PEDESTRIAN / BICYCLE SAFETY REVIEW

US 1 / University Boulevard to New Haven Avenue

February 2016

Pedestrian/Bicycle Safety Review Report for US 1 (Melbourne) from University Boulevard to New Haven Avenue

Figure 14

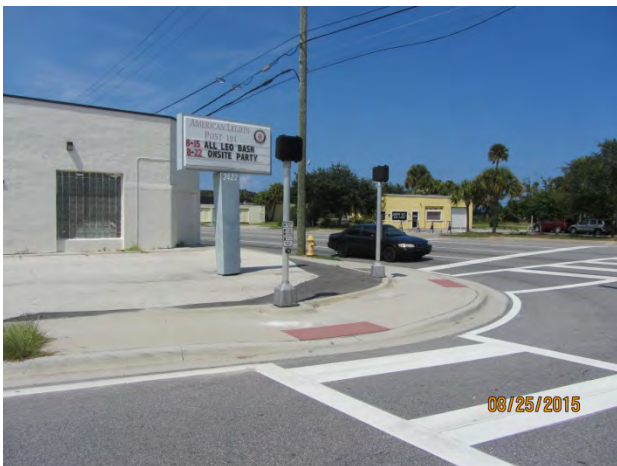
Along the US 1 corridor, development patterns allowed for buildings to be constructed up to the corner of intersections (both signalized and unsignalized) and driveways, as displayed in **Figure 12** through **Figure 15**. Two of the 12 crashes occurred where there was limited sight distance at a driveway/intersection due to a building on the corner.

The City of Melbourne has long term plans to redevelop along this section of US 1. As properties redevelop, enforce the City of Melbourne building setback standards so as to increase the sight distance at these driveways and intersections.

Figure 21

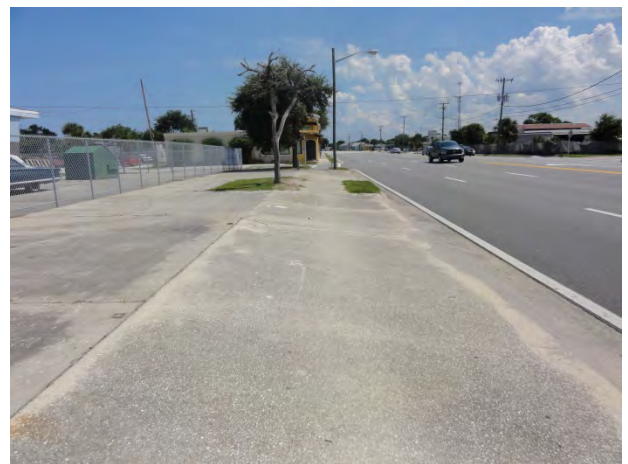
At some driveways throughout the corridor, the sidewalk merges into the existing driveway as displayed in **Figure 18** through **Figure 21**. With the sidewalk not being stand alone, it is subject to the cross slope of the driveway, which in most cases was between seven and 12 percent (based on field review measurements by the study team). The driveways measured exceeded the maximum two (2) percent cross slope per section R302.6 in the ADA PROWAG guidance.

Along the study corridor, properties were observed as having multiple driveways onto US 1. Some of these properties were undeveloped parcels (**Figure 20**) while other properties currently do not have access to their driveways (**Figure 19** and **Figure 21**). A number of driveways were also noted to be longer than the 36' maximum driveway width as specified per FDOT Standard Index 515. While there was not a high amount of pedestrian/bicycle crashes at driveways (2 out of the 12 crashes), driveways are conflict points between pedestrians/bicyclists utilizing the sidewalk and vehicles exiting the property or turning from US 1. The higher the number of driveways along a corridor, the higher the potential for crashes between a pedestrian/bicycle utilizing the sidewalk and a vehicle exiting/entering a property.

Consider driveway reconstruction during the roadway's next 3R project to provide a level path for the sidewalk and meet ADA guidance. As part of this construction, consider reducing the driveway widths down to the 36' maximum per FDOT Standard Index 515. Also as part of this future 3R project, consider eliminating unused driveways, like those shown in **Figure 19** and **Figure 21**. US 1 was recently resurfaced from Roosevelt Avenue to north of New Haven Avenue, thus this may not happen for another 5 to 10 years. As properties redevelop along the corridor, consider rebuilding the driveways. It appears these improvements can be done without negatively impacting parking or site circulation on the subject parcels.

To address the issue of multiple driveways for the same property, consider driveway consolidation during potential redevelopments where feasible. For currently undeveloped properties, consolidating these driveways during development will reduce the amount of conflict areas between pedestrians/bicyclists and vehicles. Some local government agencies around Central Florida have incorporated land use policies encouraging pedestrian cross access between adjacent commercial and office properties. Cross-access between adjacent parcels within a block should be a focus on the US 1 corridor as properties redevelop which would help eliminate unused or underutilized driveways.

Figure 24

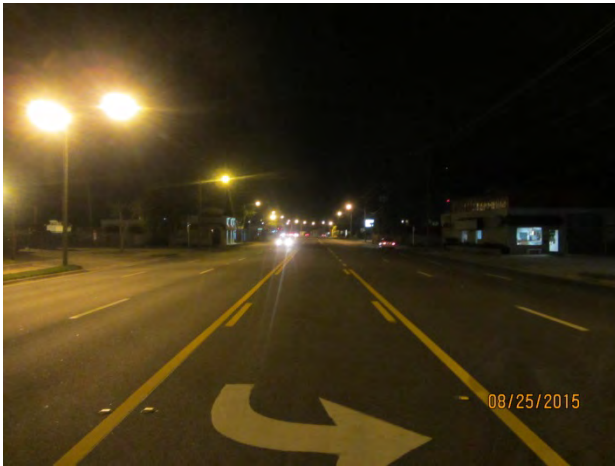
The field review team noted multiple lights were burnt out along the corridor contributing to the inconsistent lighting issue.

Even though overhead lighting is present along the corridor, the spacing of the lighting is inconsistent. With the inconsistent spacing, there are areas along the corridor where dark spots are present making it more difficult for motorists to see pedestrians/bicyclists. In total, six (6) of the 12 crashes occurred under dark lighting conditions with all three fatal crashes happening at night. Two of those six crashes involved pedestrians/bicyclists crossing the roadway between signalized intersections, with one of those being a fatal crash.

Consider contacting the operator/maintainer of the lighting system to replace the burnt out light bulbs along the corridor.

Consider a lighting uniformity study to review lighting consistency along the corridor. Providing consistent spacing of the lights along the corridor will make the pedestrians/bicyclists more visible during dark lighting conditions.

During implementation of the results of the study, consider changing from the current high pressure sodium lights to LED lighting to help improve lighting levels along the corridor.

Figure 36

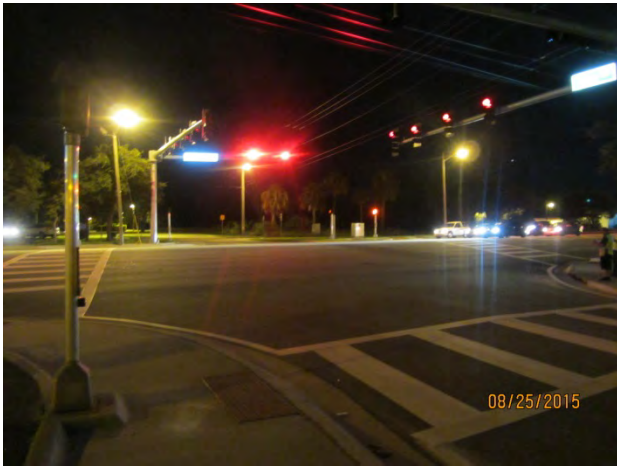
Intersection lighting is provided on the southeast and northeast corners of the intersection as displayed in **Figure 36**. No intersection lighting is provided on the southwest (**Figure 37**) or northwest corners of the intersection.

Consider upgrading the lighting at the intersection to meet the requirements of section 7.3.2.2 in Volume 1 of the FDOT Plans Preparation Manual (PPM). This may require the existing lighting to be replaced.

Figure 38

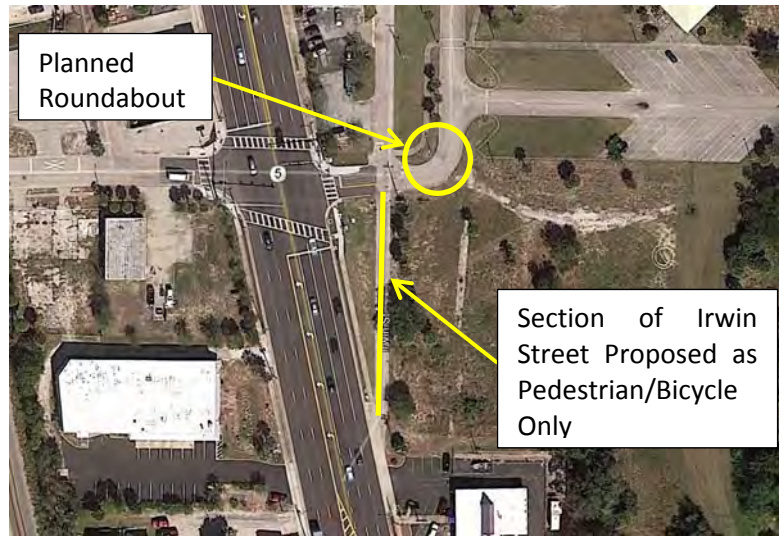
During the field review, multiple pedestrians were observed walking along Irwin Street south of Line Street. This roadway begins at a driveway from US 1 approximately 250' south of the Line Street intersection (**Figure 38**) and extends into Melbourne Riverview Park. City staff noted this section of Irwin Street is rarely utilized for vehicular traffic.

The City of Melbourne has plans to redevelop Riverview Park (see **Appendix B** for plan). With this redevelopment, having easily accessible pedestrian/bicycle routes to the new park is key to generating activity within the park. The study team considered removing the driveway from US 1 to Irwin Street and making the section up to Line Street a pedestrian/bicycle only facility. A roundabout is proposed near the intersection of Line Street and Irwin Street so the pedestrian/bicycle only facility could tie into the future design of that intersection.

Figure 42

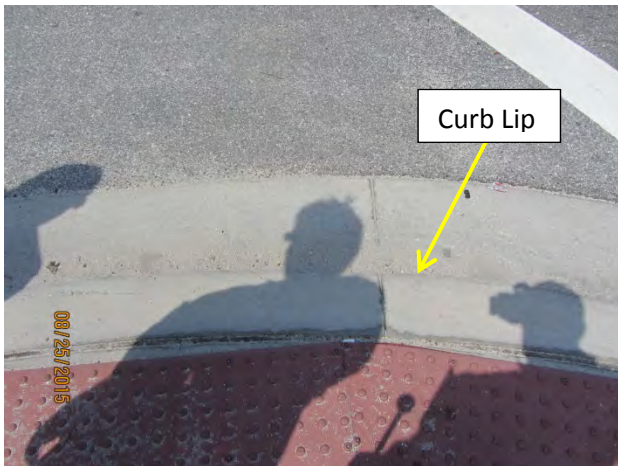
When the curb return on the southwest corner of the intersection was constructed, the valley gutter was built with a lip as displayed in **Figure 42** and **Figure 43**. The lip constructed may make it difficult for a wheelchair pedestrian to exit the crosswalk utilizing the curb ramp to access the sidewalk.

Consider beveling the lip or rebuilding the curb return so there is no lip on the valley gutter between the curb ramp and the roadway.

Figure 47

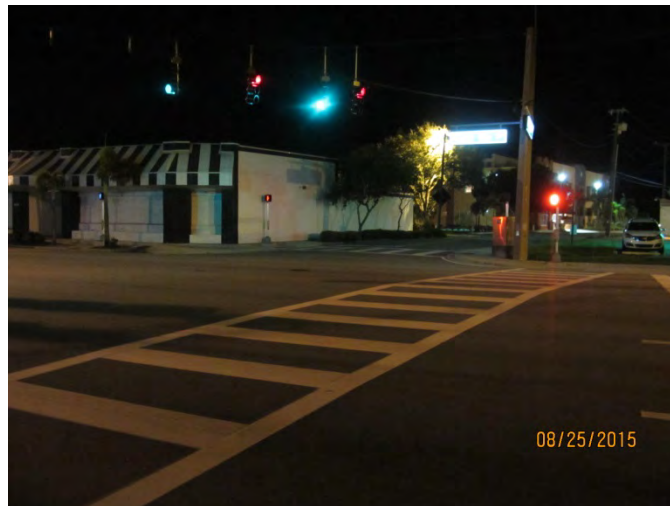
Intersection lighting is provided on the southeast and northwest corners of the intersection. No intersection lighting is provided on the northeast (**Figure 47**) or southwest corners of the intersection. One fatal nighttime crash occurred on the south leg crosswalk in the southwest corner of the intersection while another nighttime crash occurred near the northeast corner of the intersection.

Consider upgrading the lighting at the intersection to meet the requirements of section 7.3.2.2 in Volume 1 of the FDOT PPM. This may require the existing lighting to be replaced.
